DESIGN BULLETIN #70/2010

Highway Geometric Design Guide Centreline to Centreline Spacing For New Rural Divided Highways

FIGURE C-6.1 RURAL MULTI-LANE DIVIDED HIGHWAY STAGING

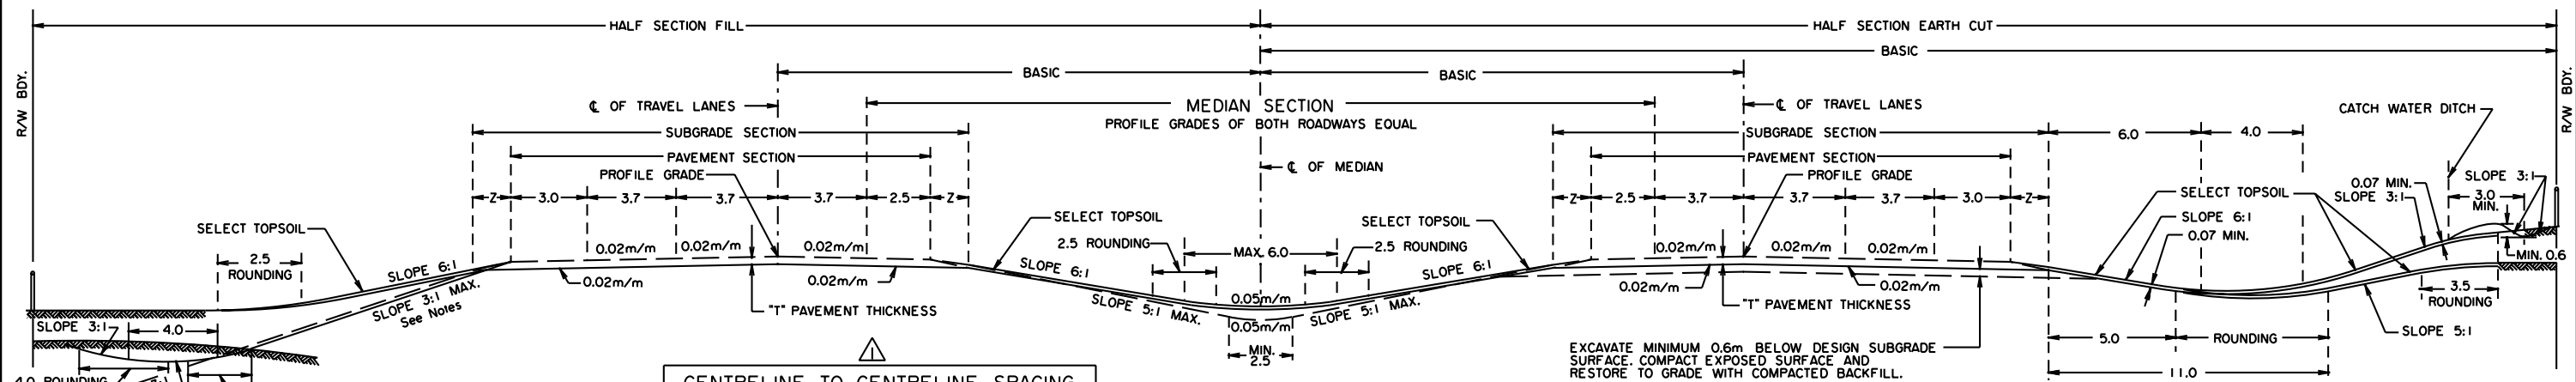
- When four-lane divided highways need to be upgraded to six or eight lanes (expressway or freeway) to increase capacity or level of service, the median spacing can still accommodate design vehicles up to a WB-23 design vehicle (25m length), which is beneficial especially at the expressway stage. At the eight lane divided highway stage, the facility typically will have very strict access control and therefore the operational difficulties at at-grade intersections are minimized. Figure C-6.1 illustrates the divided highway staging.

The centerline to centerline spacing shall be based on design vehicle measurements. Provision for refuge of design vehicles in the median of at-grade intersections is a key factor. Spacing of 55m or more is desirable at all major at-grade intersections with truck-trailer turning movements. A reduced median may be used between intersections if required due to constraints.

THE CENTRELINE TO CENTRELINE SPACING SHALL BE BASED ON DESIGN VEHICLE REQUIREMENTS. PROVISION OF REFUGE FOR DESIGN VEHICLES IN MEDIAN OF AT-GRADE INTERSECTIONS IS A KEY FACTOR. SPACING OF 55m OR MORE IS DESIRABLE AT ALL MAJOR AT-GRADE INTERSECTIONS WITH TRUCK-TRAILER TURNING MOVEMENTS. A REDUCED MEDIAN MAY BE USED BETWEEN INTERSECTIONS IF REQUIRED DUE TO CONSTRAINTS. REFER TO FIG. C-6.0 FOR FUTURE DETAILS.

FIGURE C-8.2a

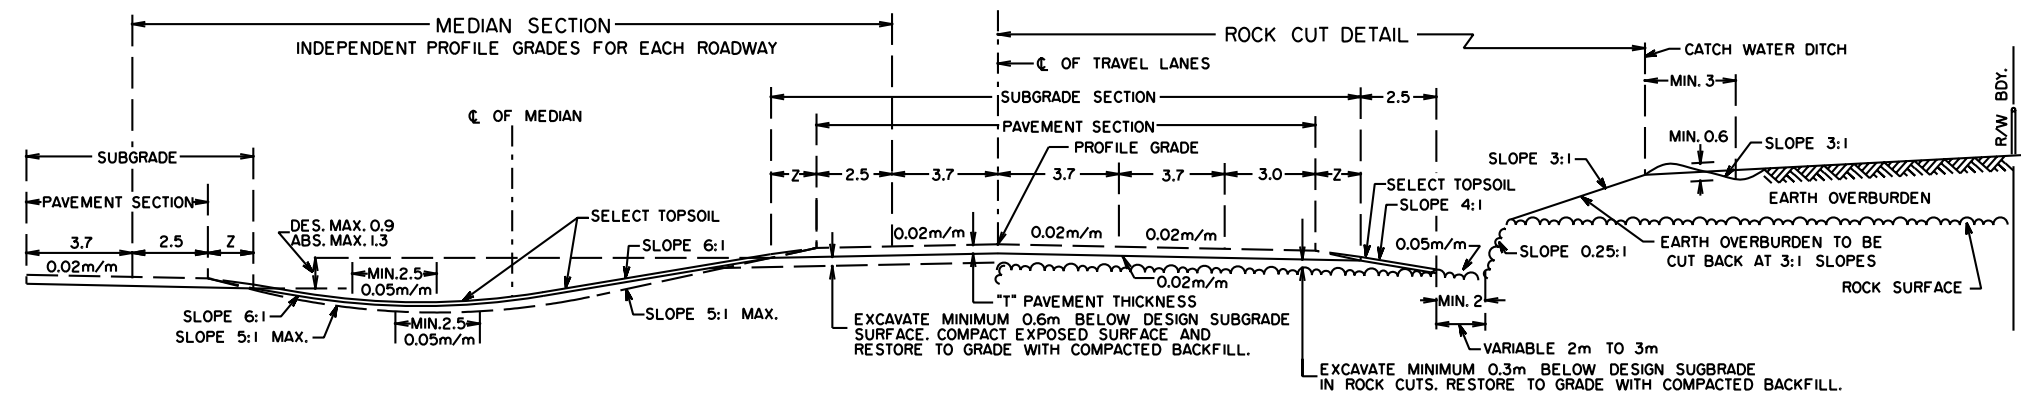
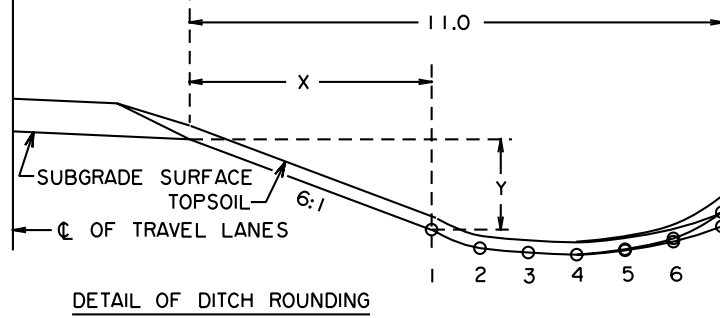
1. Figure C-6.0, Typical Centreline to Centreline Spacing for New Rural Divided Highways in Alberta.
2. Figure C-6.1, Rural Multi-Lane Divided Highway Staging
3. Figure C-8.2a - Rev.1, Standard Cross-section for Six Lane Divided Highway RFD/RAD-616.6-130.
